Re - Casey Fields South (Employment) and Devon Meadows
Precinct Structure Plan
165 – 215 Clyde Five-Ways Road, Clyde

KLM Spatial acts on behalf of Galileo Clyde Fiveways Pty Ltd in providing the following response to the exhibited Draft Casey Fields South (Employment) and Devon Meadows Precinct Structure Plan ('the PSP'). Galileo Group is an independent Australian development group with many successful greenfield developments in Melbourne's south-east.

Figure 2: From Plan 9 Infrastructure & Development Staging, Draft CFSDVPSP. Outfalls as numbered

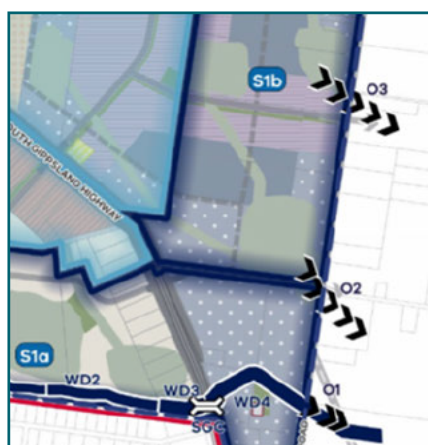
However, we consider the lack of a secure outfall at 02 to Rutherford Creek is a major inhibitor to the development of approximately 75% of the precinct north of Moore Road. The existing culvert at Moore Road disperses across neighbouring farmland. The absence of a secured outfall will prevent and frustrate the delivery of land and jobs across the core of the precinct.

Figure 3: Alternative Drainage Concept

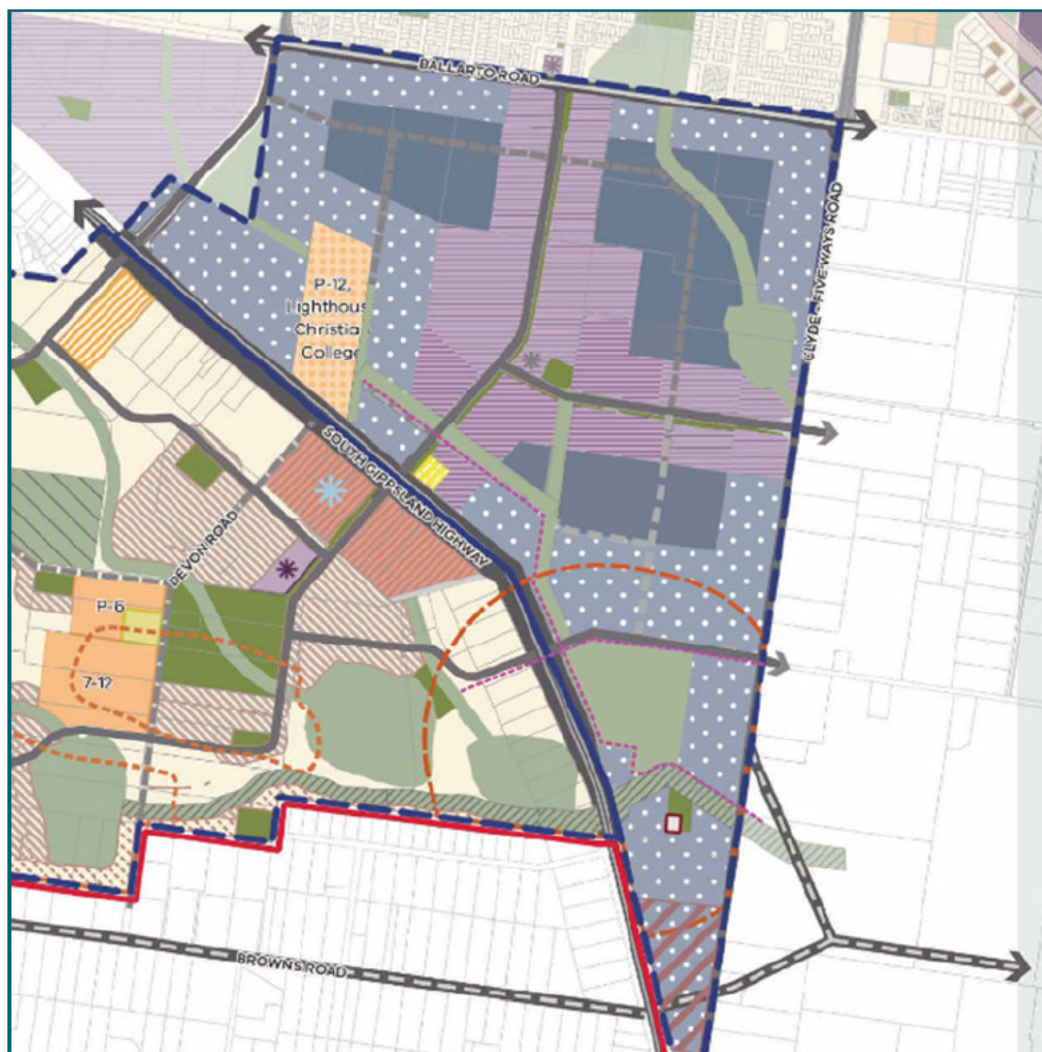
Galileo presents an alternative drainage strategy intended to provide for efficiency of drainage outfall and assets with a guaranteed outfall to unlock land development by way of:

- Combining outfalls 01 and 02 with an outfall at 01 secured by the PAO by diverting drainage from the central northern catchment to the south of the proposed Moore Road extension,
- Providing an efficient wetland within a natural low lying basin area connecting to the PAO outfall and extending the PAO to include this wetland,
- Providing primary treatment upstream prior to stormwater entering the channel system,
- Locating the alternative wetland within a location that is largely impacted by a Land Subject to Inundation Overlay,
- Realigning of waterways north of the Moore Road extension to direct drainage to the alternative wetland, and
- Producing land efficiencies for 215 and 235 Clyde-Fiveways Road and 1805 South Gippsland Highway through the alternative wetland proposal.

The alternative drainage scheme achieves an approximate **40% reduction of wetland area** and a minor reduction of waterway length, as well as requiring two rather than three outfalls. The wetland would provide stormwater retardation for approximately 85% of the Casey Fields South precinct, only excluding the small catchment to the north-east of the precinct.

The significance of the proposed wetland provides appropriate justification that a **PAO should be applied to the wetland area**. This will enable certainty of delivery and enable the wetland to be constructed concurrently with outfall 01. This would unlock developable land in the precinct and may avoid temporary drainage works.

1. All PSP Plans 1-13 be amended to incorporate the alternative wetland and waterway configuration
2. Plan 6 Water - delete wetlands RB_01, RB_02 and RB_05
3. Plan 6 Water – Identify the alternative efficient wetland as RB_01
4. Plan 9 Infrastructure and Development Staging - Delete Outlet 02 and renumber Outlet 03
5. Table 8 Water Infrastructure – to be amended to reference to appropriate descriptors for the alternative scheme (alternative table to be provided separately)
6. Amend R8 to delete referenced documents and instead state,

Figure 6: From Alternative Drainage Scheme

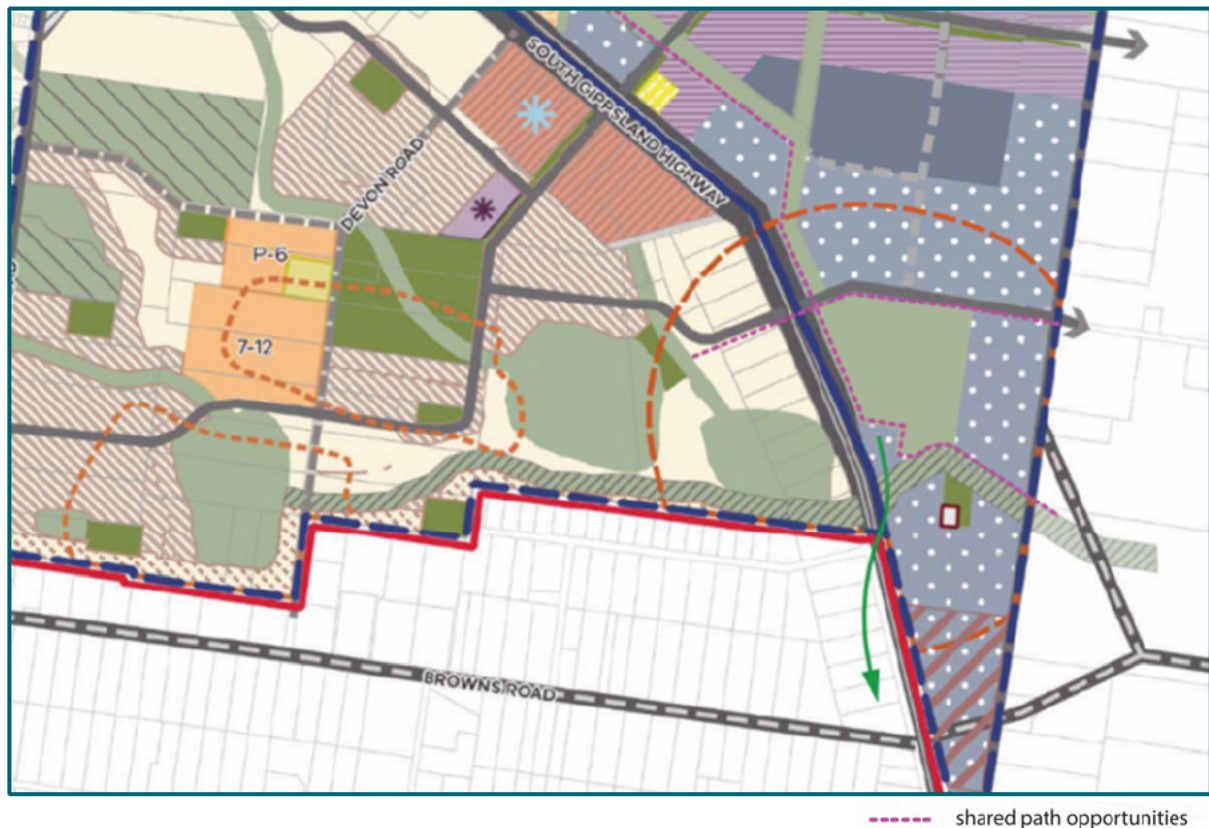
The proposed wetland location extends the 'chain of wetlands' proposed through Devon Meadows precinct eastward. This provides more opportunity for attractive open space with shared path linkages between the future Devon Meadows and Clyde South residential areas, as well extending a 'low priority link' for South Brown Bandicoot and other native flora and fauna.

Figure 7: Alternative Staging Proposal

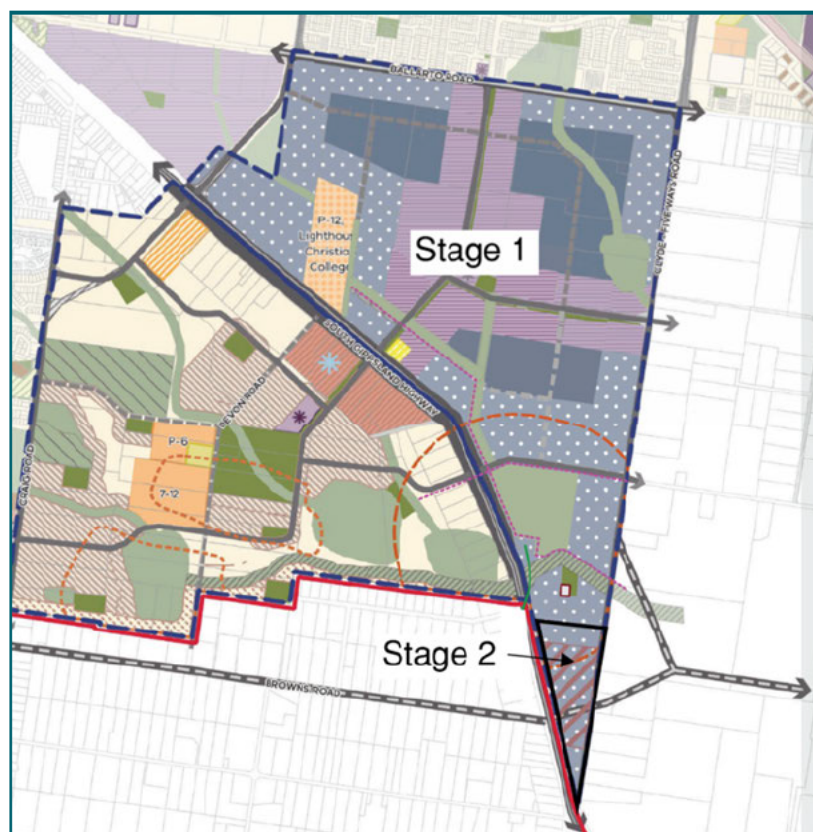
If the VPA is committed to staging the Casey Fields South precinct we suggest that the triangular Investigation Area to the far south of the precinct be nominated as Stage 2, given this area is yet to be given consideration and its development of this area will require:

Stage 1 as proposed in this submission contains two drainage catchments with proposed outlets O1 and O2. The necessity for a downstream outlet will effectively guide the development of the two catchments within the proposed Stage 1 precinct but does not otherwise need to be restrained by a stage boundary.

1. Amend Plan 9 Infrastructure and Development Staging to reflect the staging in Figure 7.
2. Amend Plan 6 Water to show a Temporary Sewer Rising Main along Clyde Fiveways Road and the Sewer Pump Station located adjacent to that road.
3. R27 be amended for Casey Fields South as follows,

Figure 8: From High Level Utility Servicing Assessment, CFSDVPSP, June 2023, SMEC

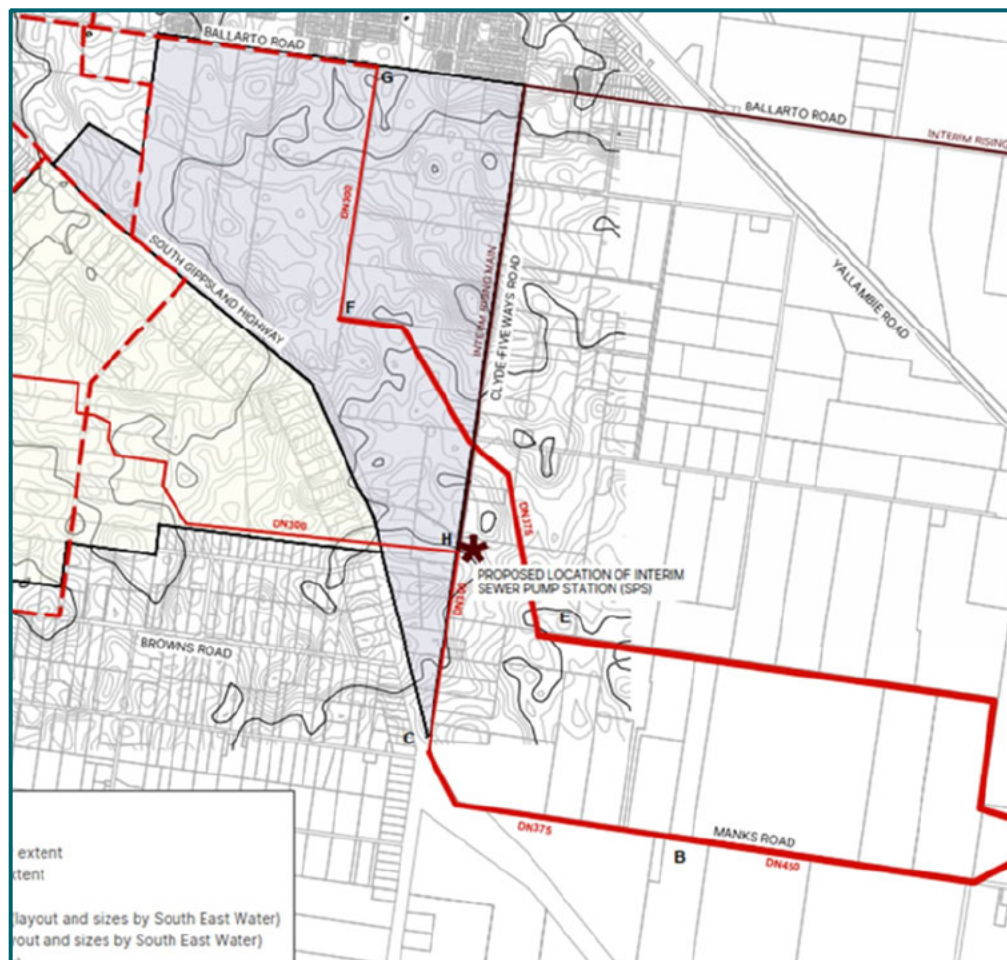
A temporary sewer rising main along Clyde Fiveways Road, as proposed in the background reporting, is a practical approach to delivering sewer infrastructure to the employment precinct given the Manks Road alignment in Clyde South may not be developed for many years due to fragmented ownership in that precinct. We strongly request the temporary rising main be shown in the PSP on Plan 6 Water.

Similarly, we suggest the temporary pump station is preferably located adjacent to Clyde Fiveways Road to facilitate access rather than central to the land parcel.

Figure 12: Clyde North industrial precinct Note direct access to key routes & parking at property frontages
Nearmap 4/3/2025

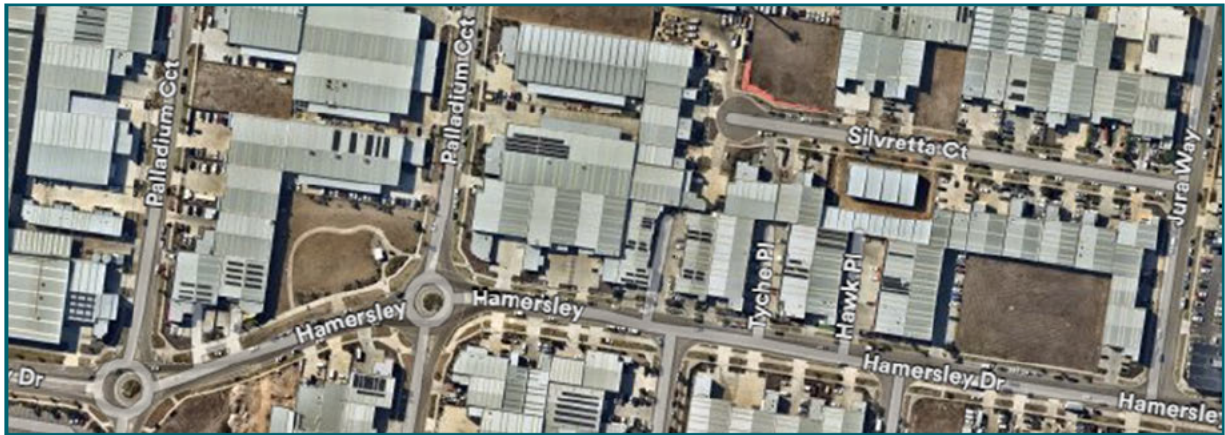
We refer to the urban form in the nearby Clyde North industrial precinct, where direct access is provided from the key route through the precinct, and the industrial urban form provides car parking to the front of premises. Most businesses in an industrial precinct require ease access for deliveries and pickups which is provided by a front car park. Zero lot lines can also cause difficulty for the connection of utility services to premises. Refer to following images of Clyde North.

Figure 13: Movement network plan with additional east-west Connector Street indicated

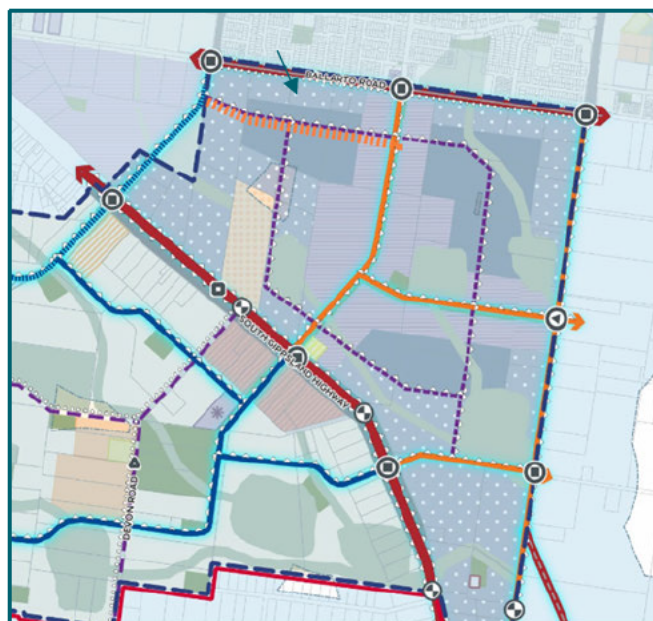
It may be desirable, however, for the northern east-west Local Access Street to be upgraded to a Connector Street to improve precinct access to the future Casey Fields Boulevard, as indicated in the image below

1. Amend Plan 4 Movement Network to:
 - Delete Local Access Streets on plan
 - Include a new east-west Connector Street to Casey Fields Boulevard as indicated in Figure 12.
2. Amend G16 by deleting the following dot point
 - Minimise vehicle access from Employment Avenue streets on Plan 4 Movement network
3. Delete Connector Street Employment Avenue cross section which does not provide for car parking.
4. Delete Limited Access Connector Street cross section which includes an unnecessary Loop Road adjacent to the Connector Street.
5. Delete Local Access Street – Employment Service Loop which does not include car parking lanes, and replace with standard 'Local Access Street – Level 2 (Industrial)' as per Officer South Employment PSP, increasing the cross-section width from 20m to 22m and noting that an off road bike path is not included. Refer following image
